Summit County Planning Commission (SCPC)

Meeting Agenda

Planning Commission
Concept Plan
Kaczmar Subdivision
Richfield Township

Review comments for the Kaczmar Subdivision Concept Plan are below:

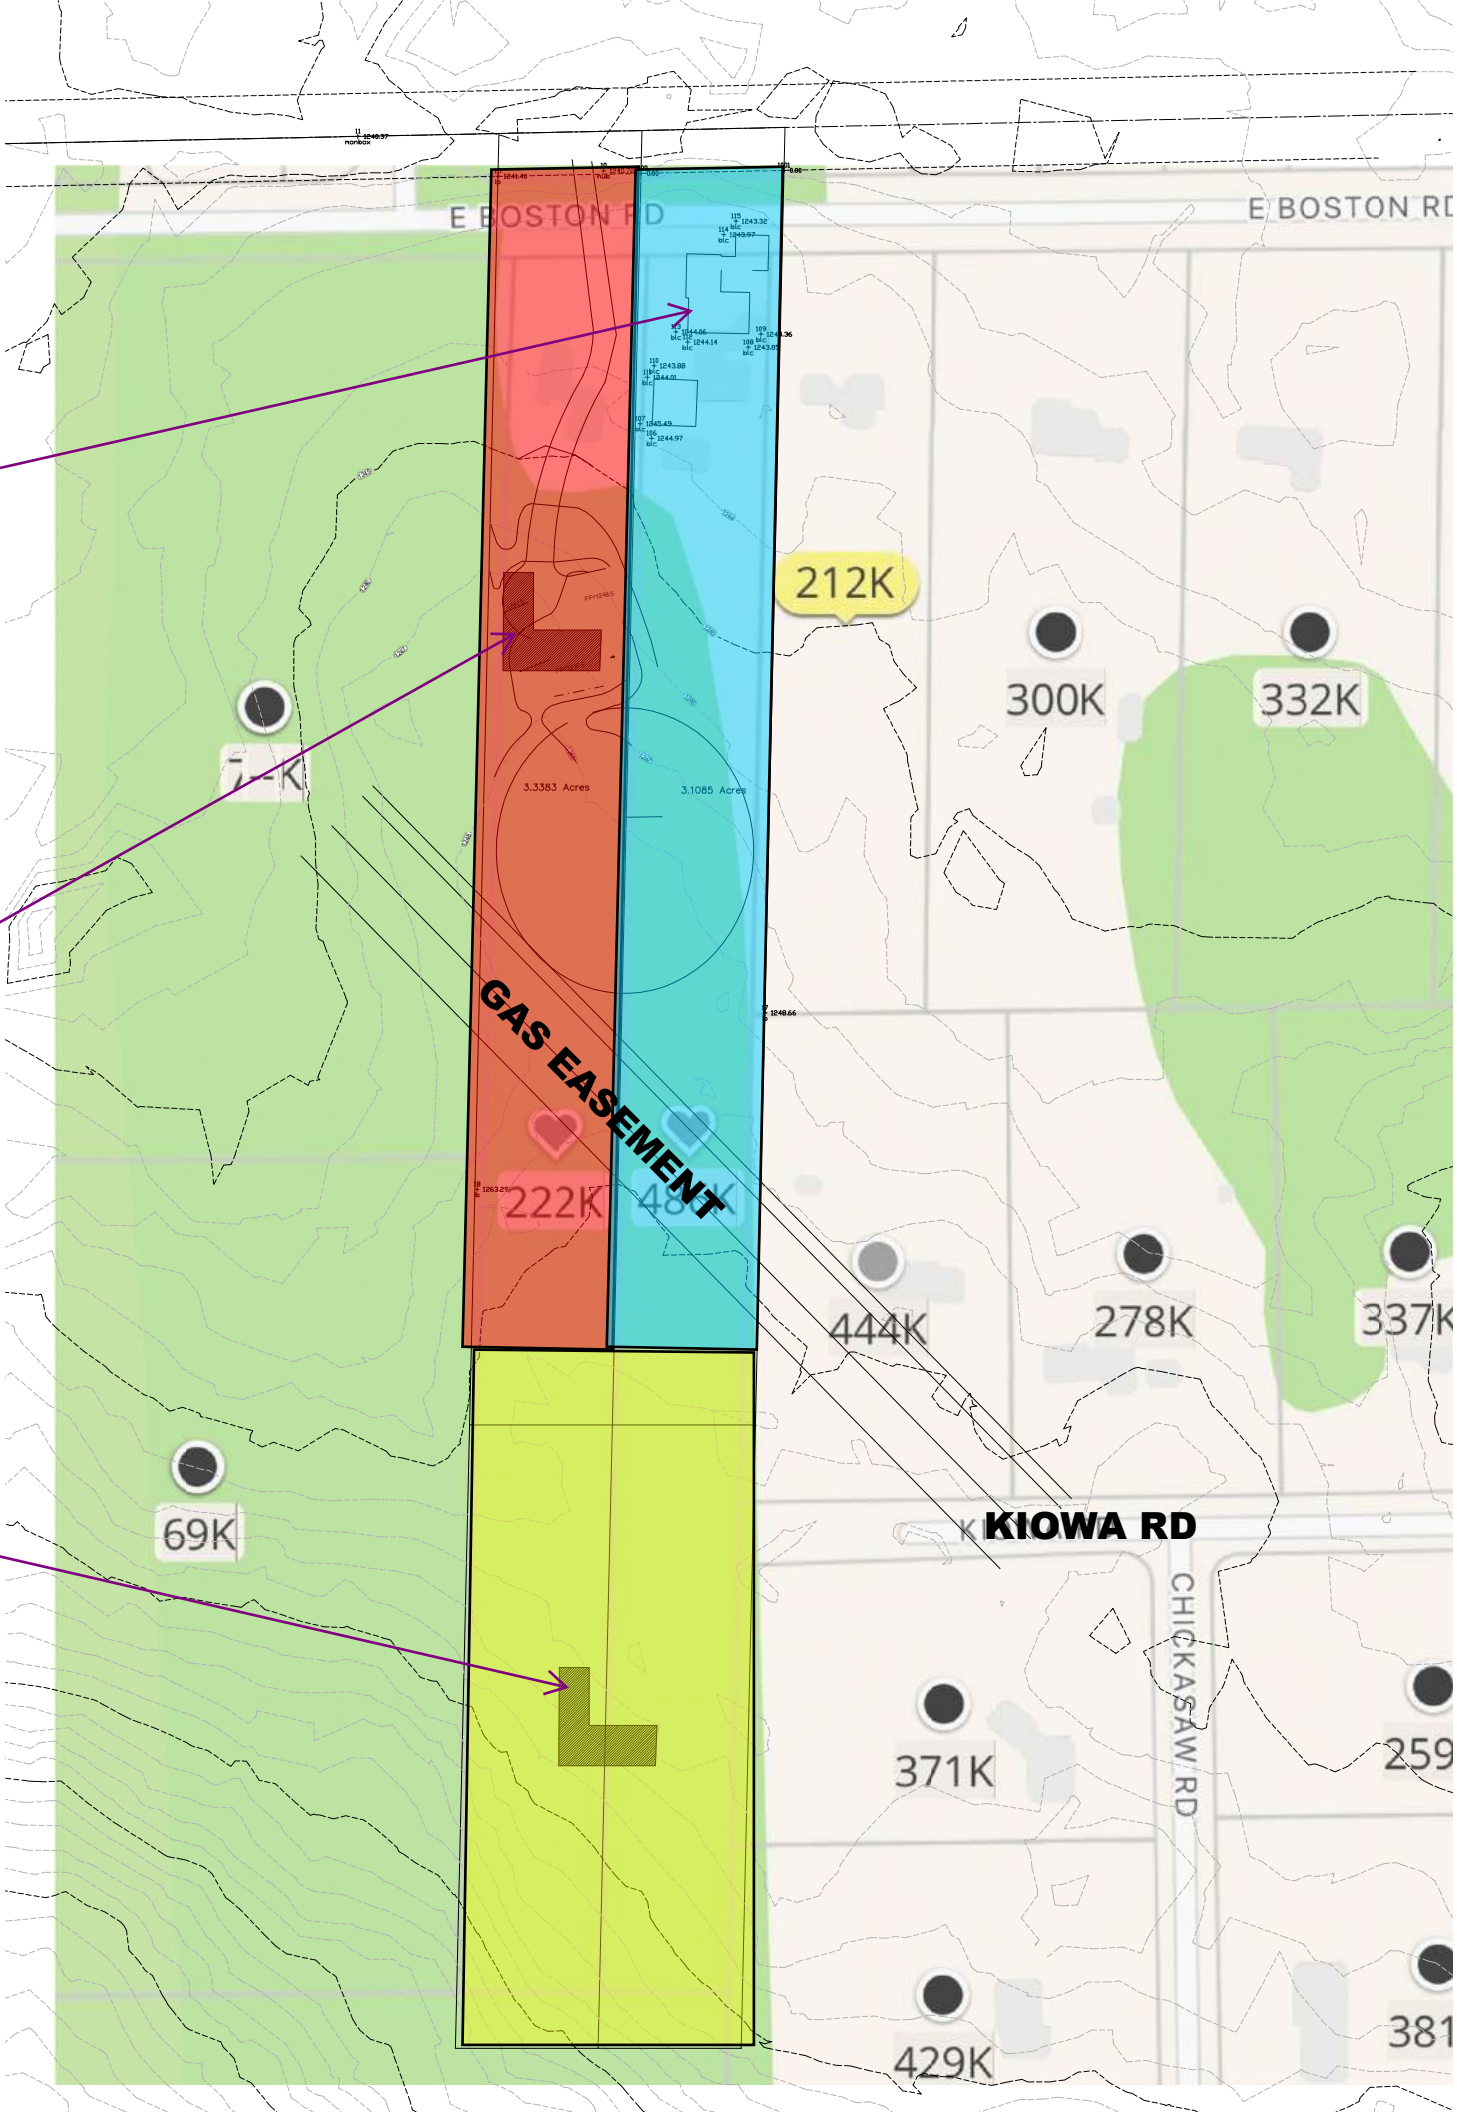
-
9. *A Traffic Impact Questionnaire for the project must be completed to determine if additional studies are warranted. This would not typically be required for a lot split, but will be required in this situation due to the project being classified Major Subdivision.*
 10. *How will utilities (gas, electric, etc...) be accessed? Should a road crossing be necessary, will the Township require the road to be bored (vs open cut)?*
 11. *A Road Opening Permit will be required for any proposed work within the existing R/W of Luther Road & Kiowa Road.*
 12. *GIS and Google Maps show 'Luther Road' as 'Boston Road'. The correct road name should be verified with the Township.*
 13. *The drawing is not formatted as a major subdivision.*

After looking plot plans and discussing with you the plans for the lots. It is my belief that you would not need a cul-de-sac for just one residential home. If there is only one driveway that comes off of Kiowa and has sufficient driveway width I do not see a need for the cul-de-sac.

Staff recommends that Kiowa Road be extended to reach Lot C, per County Highway Standards. This would include the construction of a cul-de-sac, either fully or partially on Lot C. Staff also recommends that all recommendations provided by the Summit County Engineer's Office, along with other appropriate federal, state and local statutes be followed. In addition, staff endorses Summit SSWCD's recommendation to obtain a wetland delineation to determine if wetlands are present within the project area.
